# CT HVAC and Water Heater Process and Impact Evaluation Report

# CT Heat Pump Water Heater Impact Evaluation Report

R1614/R1613 REVIEW DRAFT

DECEMBER 22, 2017

FIGURE 2-4: NUMBER OF REBATES BY UTILITY BY YEAR

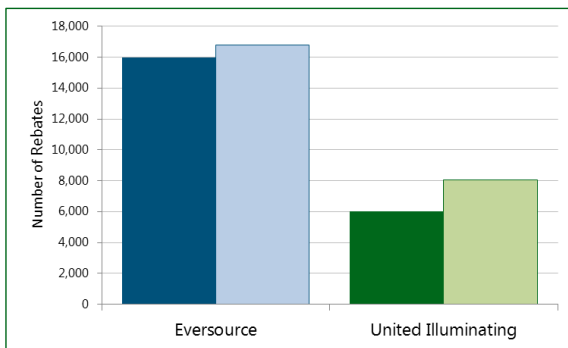
**Comment [GR21]:** The number above are much larger than those in Figures 2-3, 2-5 and 2-6. Are these all HVAC equipment?

FIGURE 2-5: NUMBER OF REBATES BY MEASURE BY UTILITY BY YEAR - EVERSOURCE

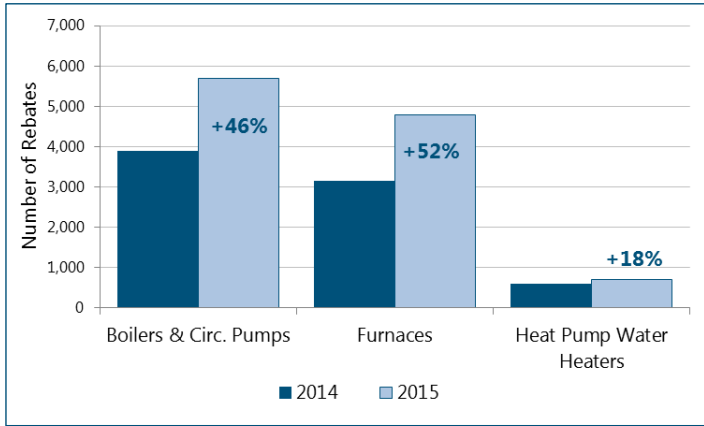
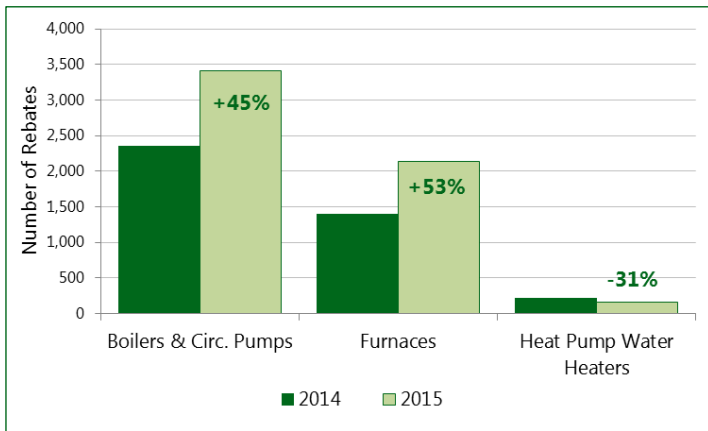
**Comment [GR22]:** Why are these combined below?

FIGURE 4-4: CONDENSING PERCENT OF HOURS BY TEMPERATURE BIN FOR BOILERS

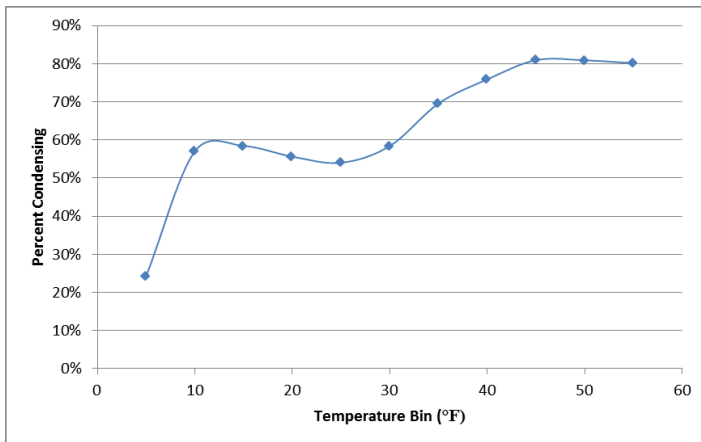
**Comment [GR33]:** But not heating load, correct? An hour at 10 degrees has much more corresponding heating load than an hour at 50 degrees.

FIGURE 4-8: KW DRAW IN ELECTRIC RESISTANCE, HYBRID AND HEAT PUMP MODES

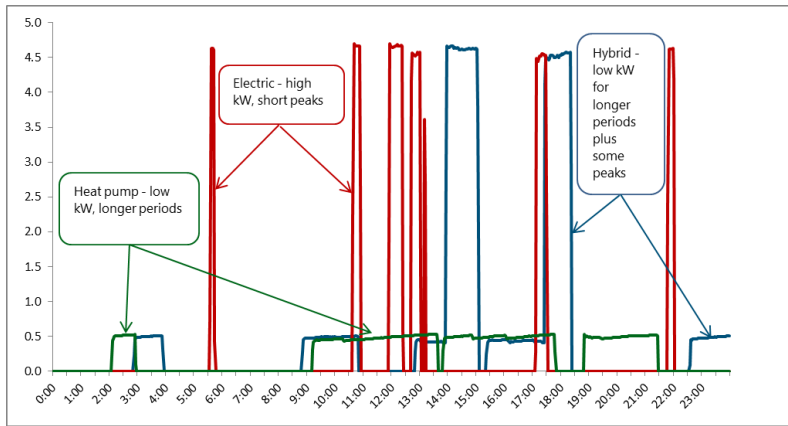
**Comment [GR56]:** Both winter and summer?
